# Access Compliance Report

## Public Rights-of-Way

### (Curb Ramps)

Intersection ID: 23489	Main Street: LENHART_DR	Cross Street: SUMMERLIN_PL	Location:	N
ADA ID: 9C113C089B60	Ramp Type: PerpDiag	Initial Pass/Fail: Fail	Overall Compliance: No	Severity Score: 13.75
Codes/Mitigation Info/Possible Solution		Field Measurements/Component Compliance

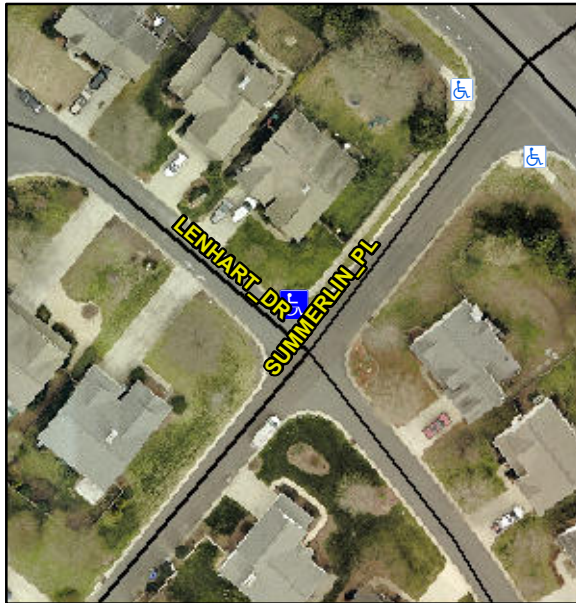
**Not Found, R304.2.2, R304.5.3**

Compliance	Description	Data	Compliance	Description	Data
N/A	Ramp Length (in)	96.0	No	Ramp Slope (%)	10.4
Yes	Ramp Width (in)	48.0	No	Ramp XSlope (%)	2.5
N/A	Flare Type LT	N/A	N/A	Flare Type RT	N/A
N/A	Flare Slope LT (%)	N/A	N/A	Flare Slope RT (%)	N/A
N/A	Flare Traversable LT?	N/A	N/A	Flare Traversable RT?	N/A
N/A	Landing Length (in)	N/A	N/A	DWS Provided?	N/A
N/A	Landing Width (in)	N/A	N/A	DWS Contrast?	N/A
N/A	Landing Slope (%)	N/A	N/A	DWS Length (in)	N/A
N/A	Landing X Slope (%)	N/A	N/A	DWS Full Width?	N/A
N/A	Landing Curb? (Y/N)	N/A	N/A	DWS Offset (in)	N/A
N/A	Shared Landing?	N/A			
N/A	Gutter Ponding?	N/A	N/A	Gutter Slope (%)	N/A
N/A	Gutter Lip Ht (in)	N/A	N/A	Gutter X Slope (%)	N/A
N/A	Painted X Walk1?	No	N/A	Painted X Walk2?	No
	X Walk 1 Direction	To SW		X Walk 2 Direction	To SE
N/A	X Walk 1 Width (in)	N/A	N/A	X Walk 2 Width (in)	N/A
	X Walk 1 Slope (%)	0.8		X Walk 2 Slope (%)	3.2
	X Walk 1 X Slope (%)	2.7		X Walk 2 X Slope (%)	1.7

**Remove & Replace Curb Ramp With Two New Directional Ramps or Equivalent.**
